ARKANSAS NUCLEAR ONE
APPENDIX R
REGULATORY CONFERENCE

July 10, 2003

Problem Statement

Risk Informed Strategy for Zone 99M

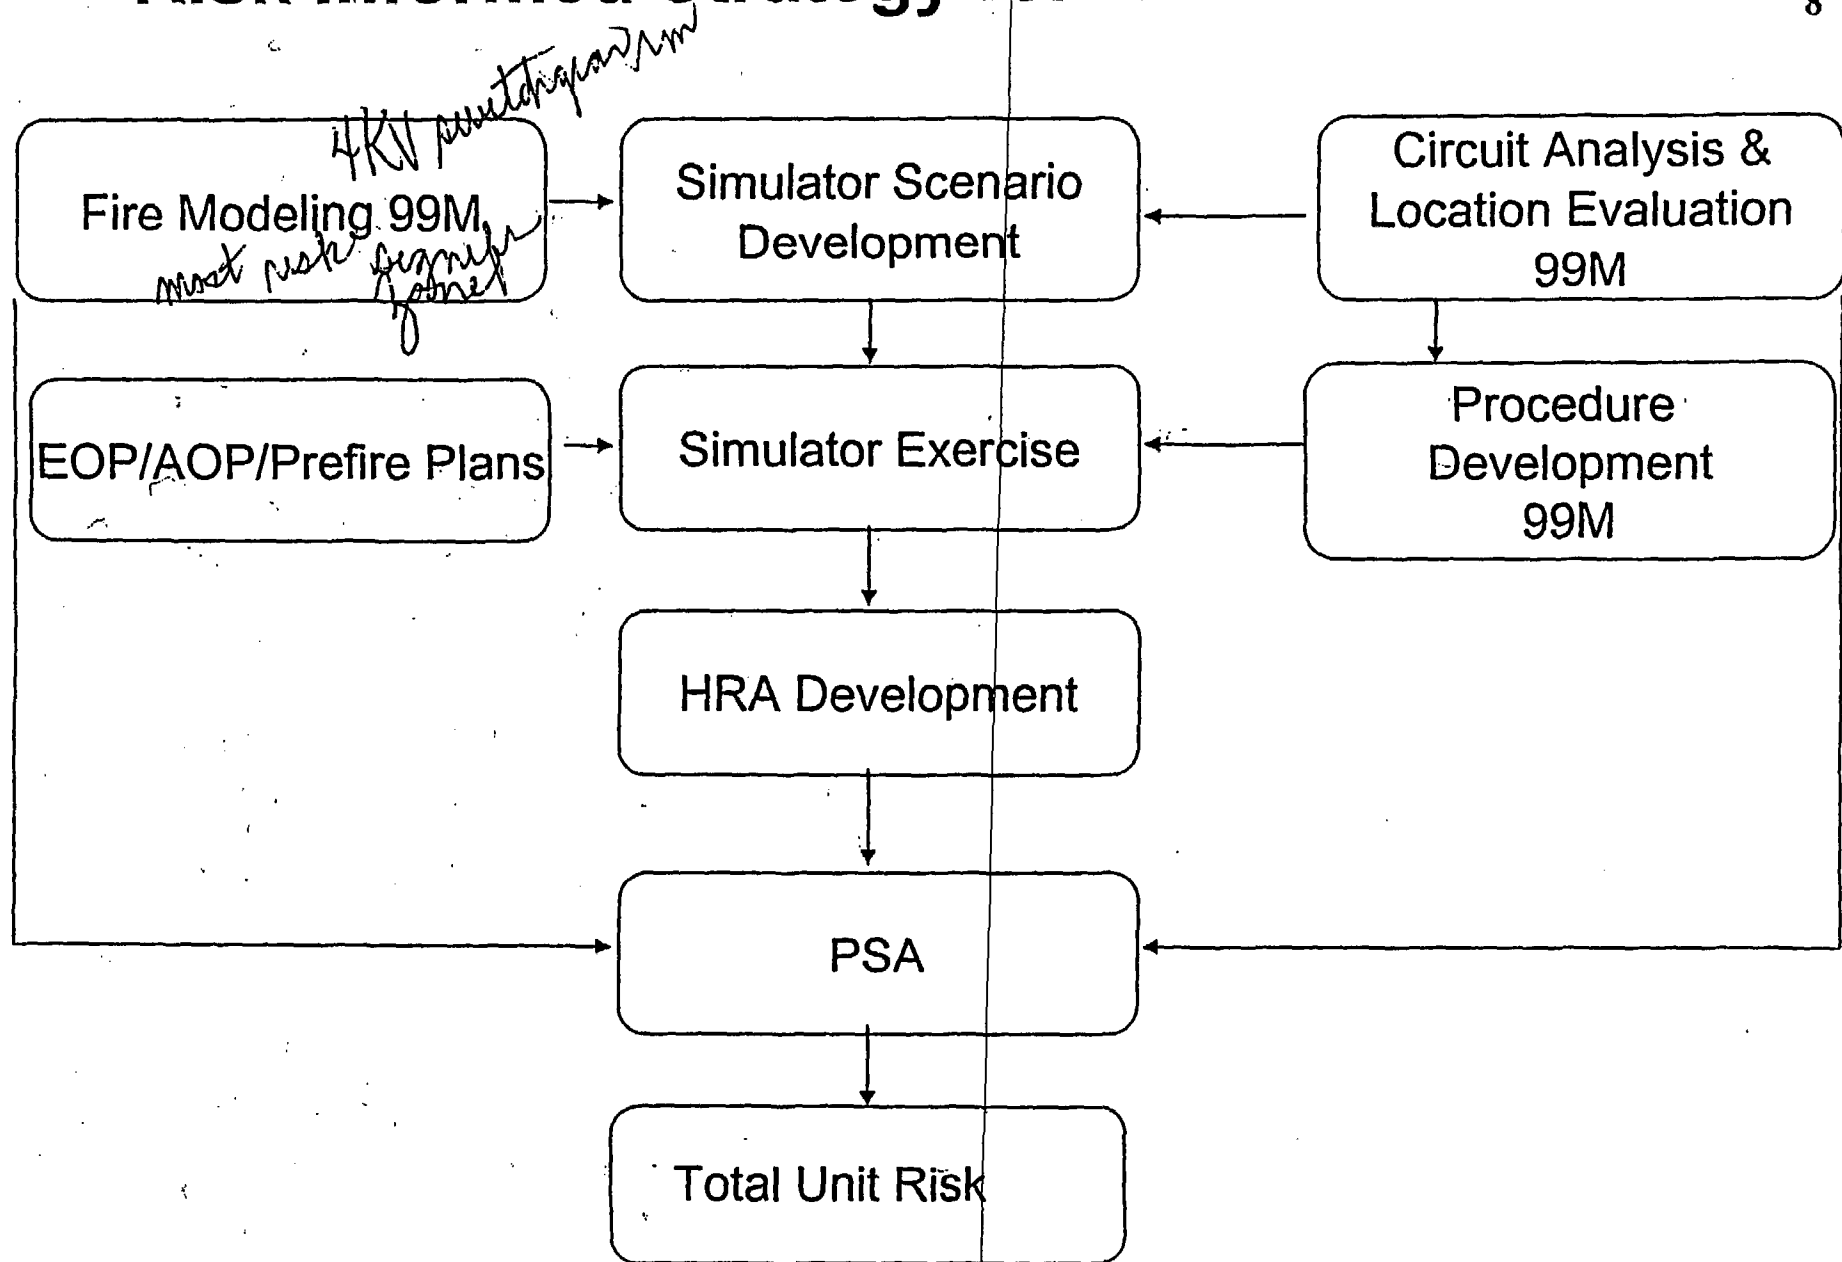
safety related notes reviewed
* *need to see raw data*
looked at each specification & determined if thermoplastic

Typical ANO switchgear cabinet wiring,
control cubicle

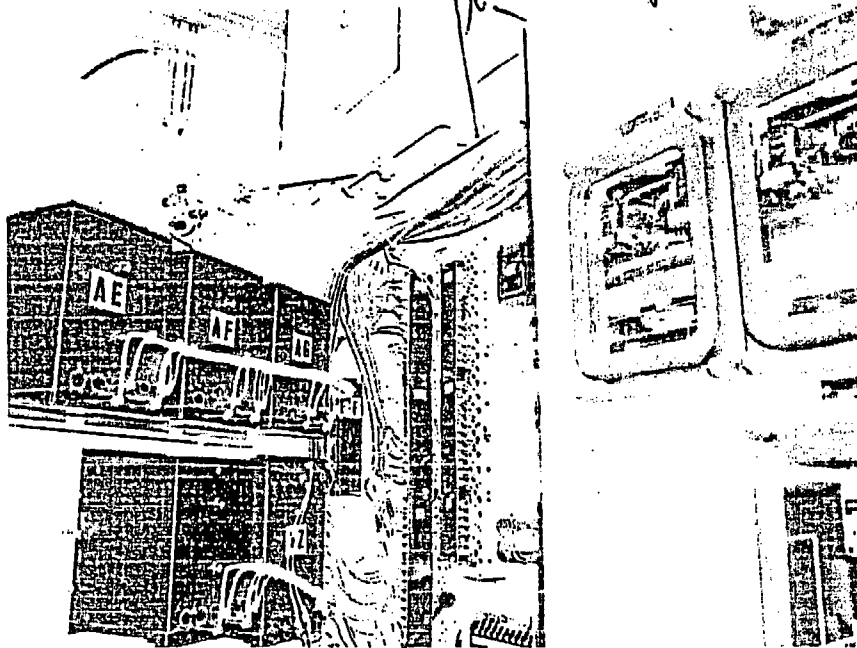
less surface burning

single bundling
